April 21, 2011

**Re: Georgesville Road Transfer Station / Franklin County  
Industrial Storm Water Permit 4GR00550\*DG**

GS/nsm Gerogesville Road Transfer Station, April 12, 2011

Georgesville Road Transfer Station  
Transfer activities coming in contact w/SW  
Discharge from site  
Scioto River Watershed  
April 11, 2011  
Photo by: Greg Sanders

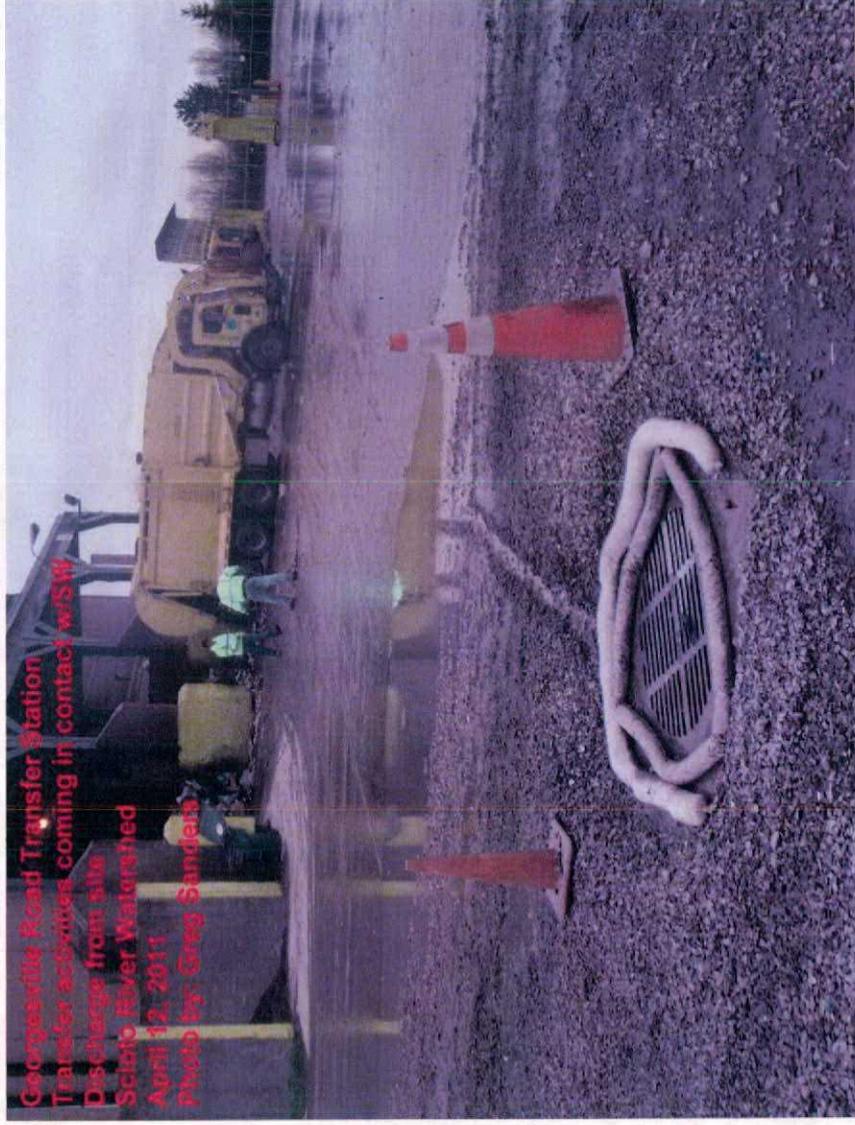
5. I noted during the inspection that storm water was still coming in contact with the daily activities of handling the trash. Also, I noted a channel that directed the contaminated storm water to a storm water drain. Please conduct all daily activities under roof to prevent storm water coming in contact with trash.
